## **WIVENHOE DAM**

### **FIVE YEAR COMPREHENSIVE DAM SAFETY INSPECTION REPORT**

September 2010

**Broken/Blocked Road Drain**

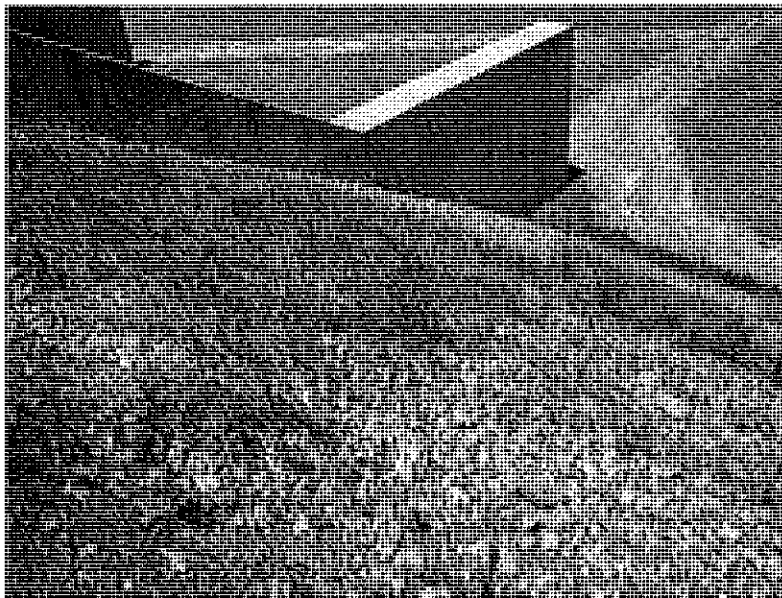
- ***The drains under the wave wall are to be modified to prevent blocking and a store of suitable plugs is to be kept at the dam to enable these drains to be closed off in the event of a flood that impacts on the wave wall (In these circumstances the road would be closed due to flooding and would not be used by the public). This issue is outstanding from the 2008 inspection.***

**Broken/Blocked Road Drain**

**Vegetation to be sprayed**

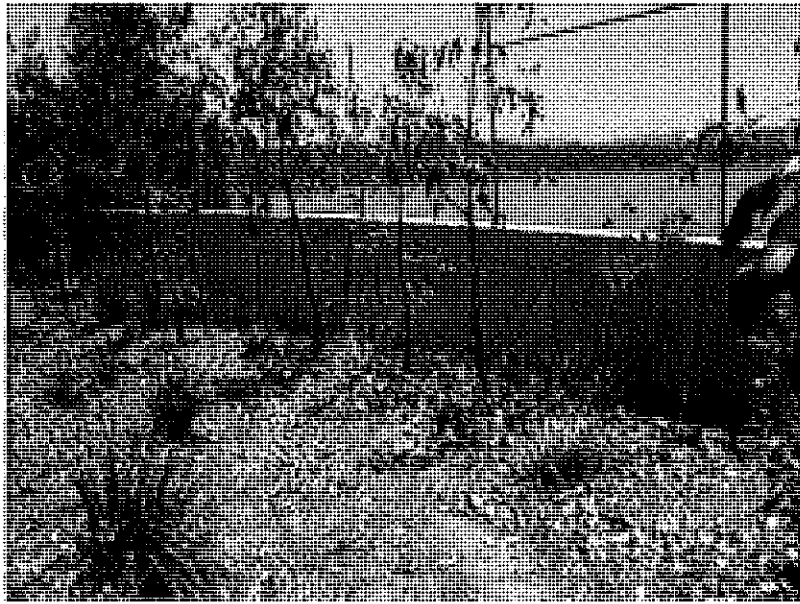
- ***Some minor vegetation is evident on the embankment face and the current weed spraying program should continue.***
- ***Some seepage is evident through the fuse plug embankments and a suitable V-notch weir is to be constructed to allow monitoring of this seepage.***

**Trees to be removed**
